LEAVENWORTH

NATIONAL FISH HATCHERY

CHELAN COUNTY, WASHINGTON

DRWG. NO. 1F-WN-257A-

Proposed lagoon.

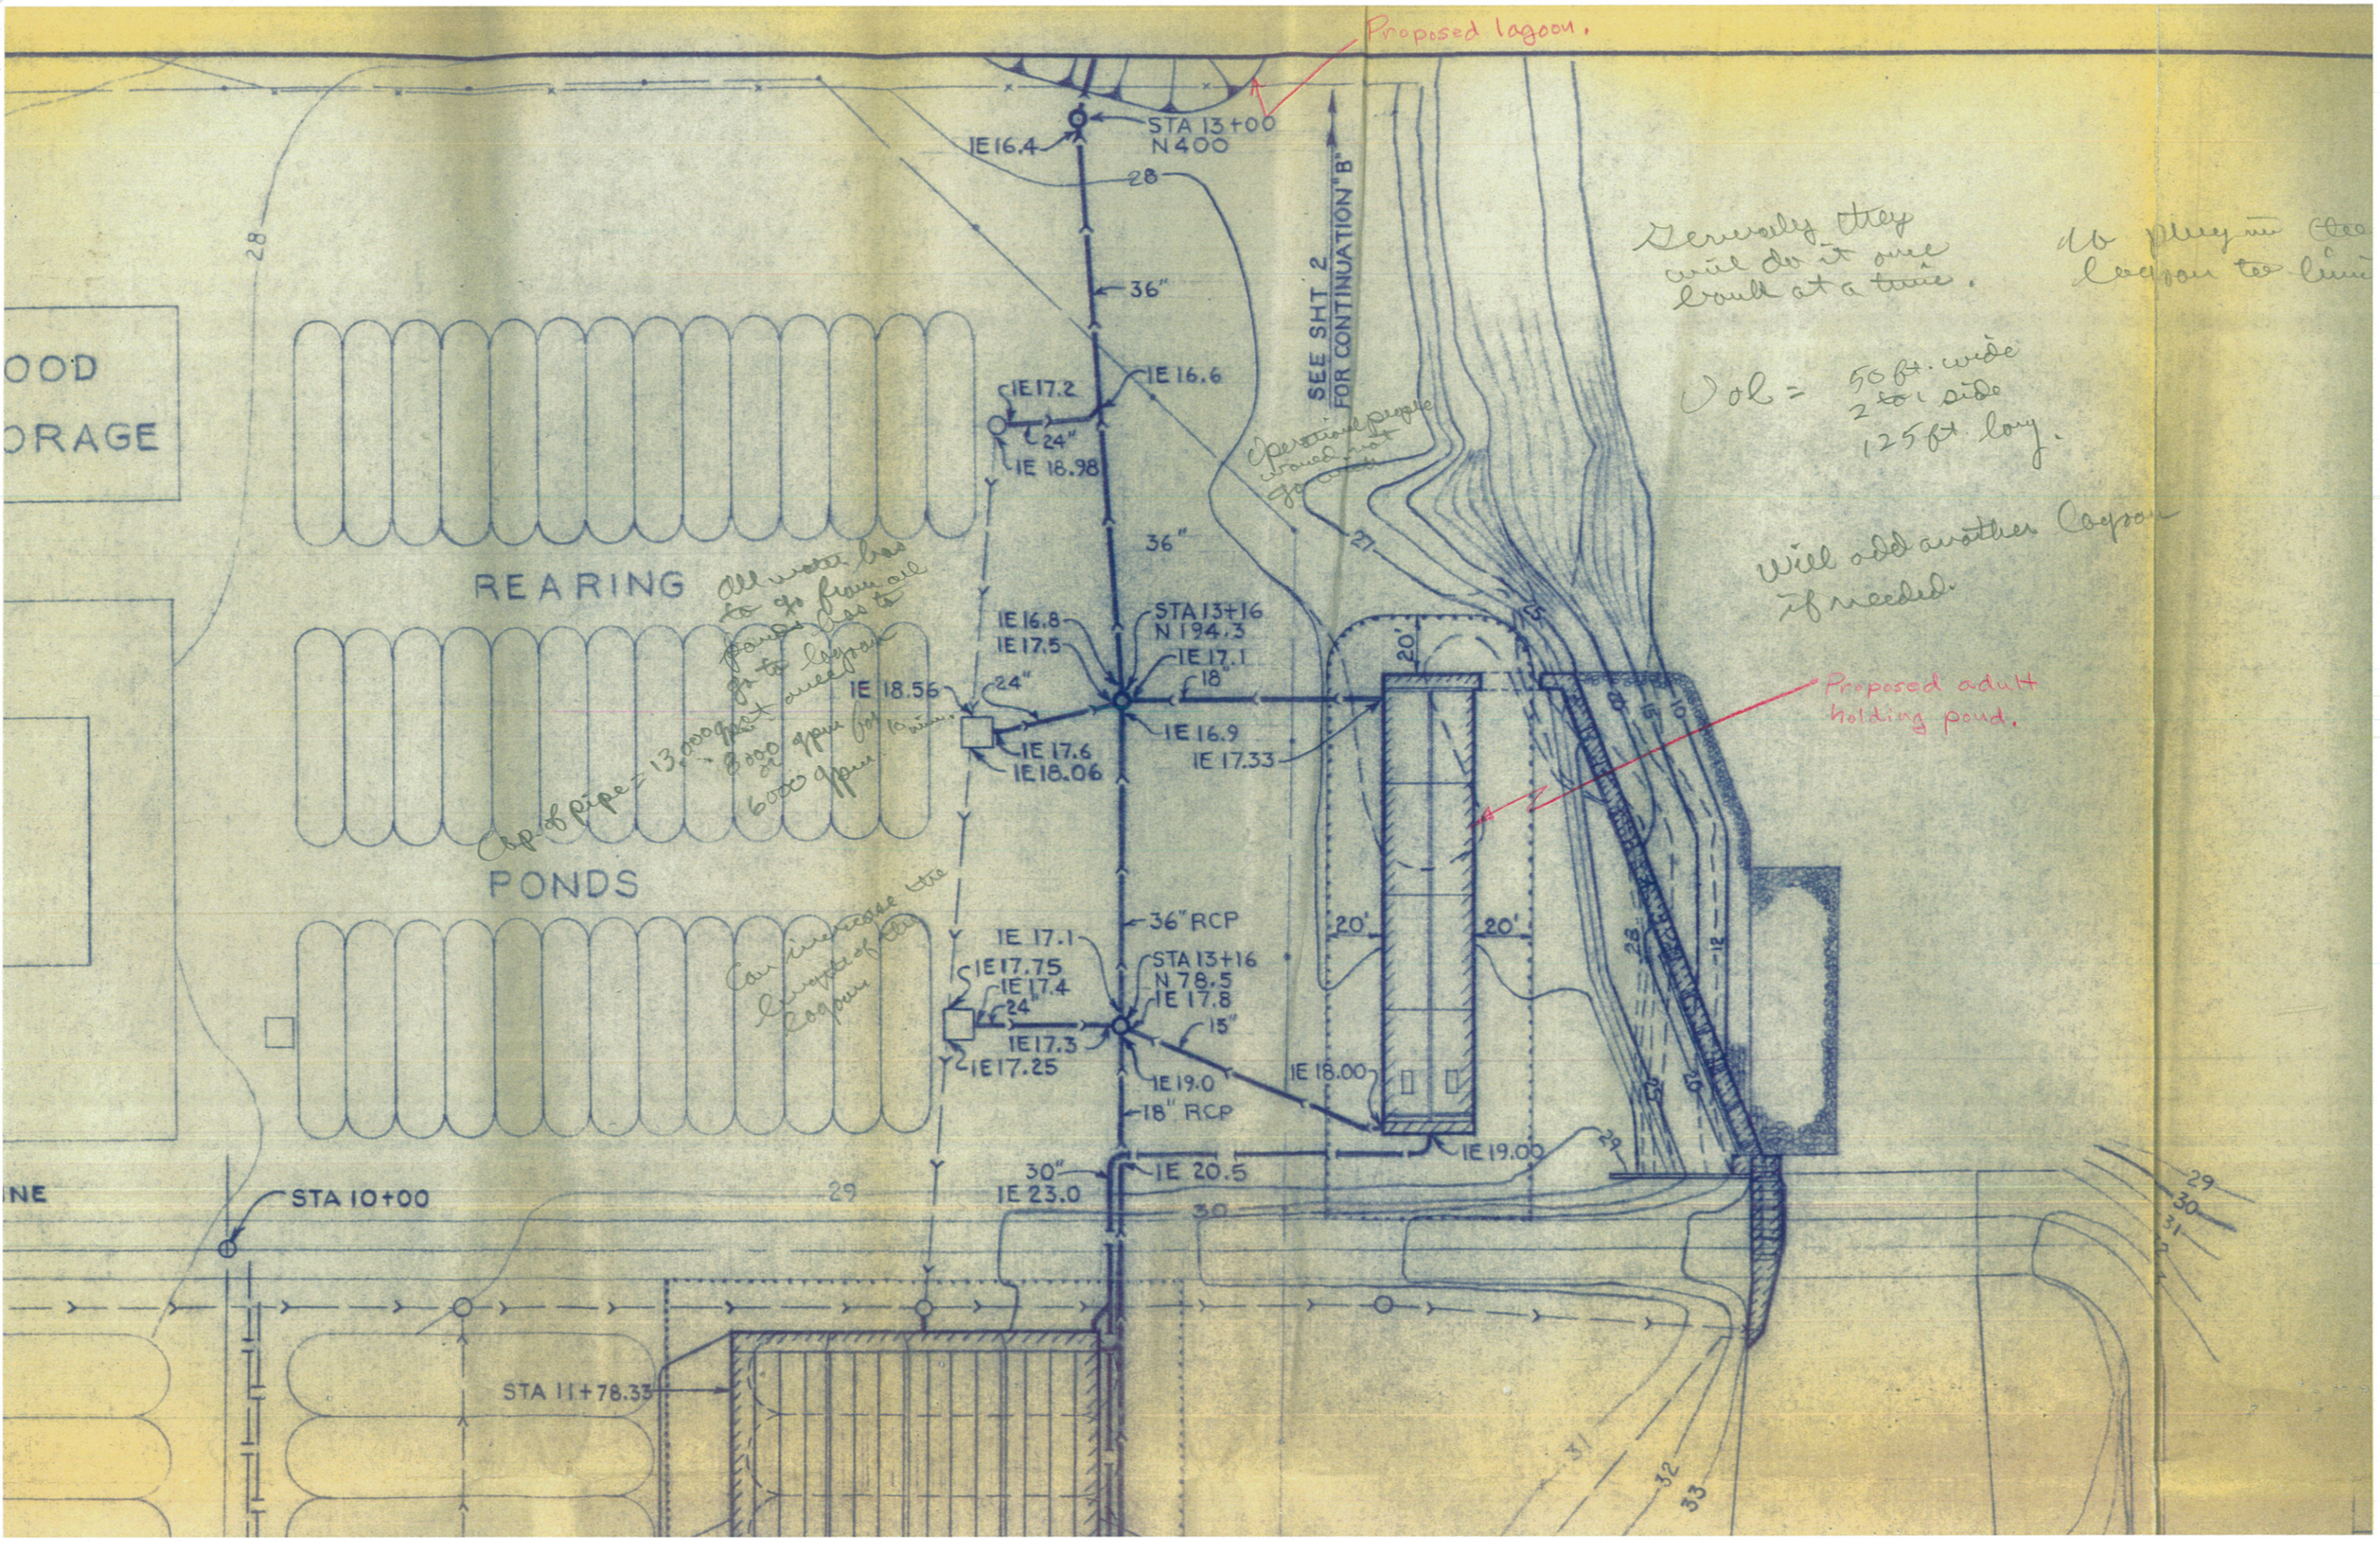
Proposed lagoon.
STA 13+00
N400
IE 16.4
28
36"
IE 16.6
IE 17.2
24"
IE 18.98
36"
SEE SHT 2
FOR CONTINUATION "B"
Operational people would not go with
REARING
PONDS
All water has to go from all ponds has to go to lagoon at once
Cap of pipe = 13,000 gpm
8000 gpm for 10 min.
6000 gpm
Can increase the length of the lagoon
IE 16.8
IE 17.5
STA 13+16
N 194.3
IE 17.1
18"
IE 18.56
24"
IE 17.6
IE 18.06
IE 16.9
IE 17.33
20'
Proposed adult holding pond.
36" RCP
IE 17.1
IE 17.75
IE 17.4
24"
IE 17.3
IE 17.25
STA 13+16
N 78.5
IE 17.8
15"
IE 19.0
18" RCP
IE 18.00
IE 19.00
20'
20'
30"
IE 23.0
IE 20.5
STA 10+00
STA 11+78.33
29
30
31
32
33
Generally they will do it once bank at a time.
Vol = 50 ft. wide
2 to 1 side
125 ft. long.
Will add another lagoon if needed.

Generally they will do it once built at a time.

do they use the lagoon to limit.

Vol = 50 ft. wide
2 to 1 side
125 ft. long.

Will add another lagoon if needed.

Operational people should not go onto
